Access Compliance Report

Public Rights-of-Way

Intersection ID: 11450	Main Street: GRANDIN_RD	Cross Street: W MARTIN LUTHER KING JR BV	Location: W
ADA ID: 6C9751BEC6D4	Ramp Type: BlendTrans1	Initial Pass/Fail: Fail	Overall Compliance: No
		Severity Score: 10

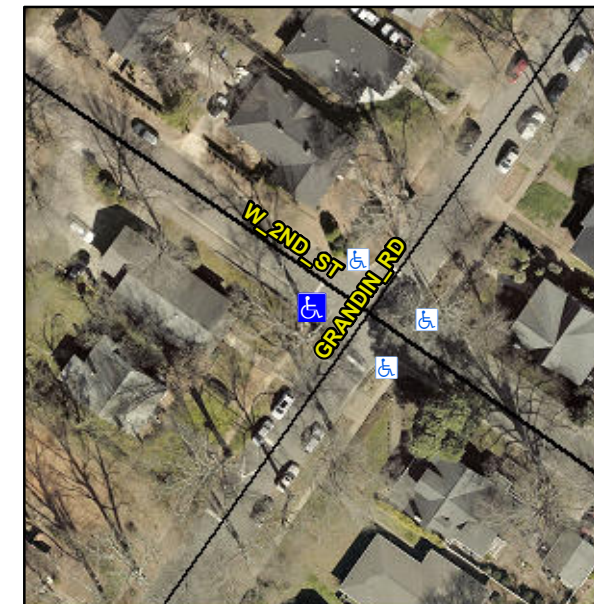
RAMP LIP 0.5

Not Found, R304.5.1, R304.5.3

Remove & Replace Curb Ramp With Two New Directional Ramps or Equivalent.
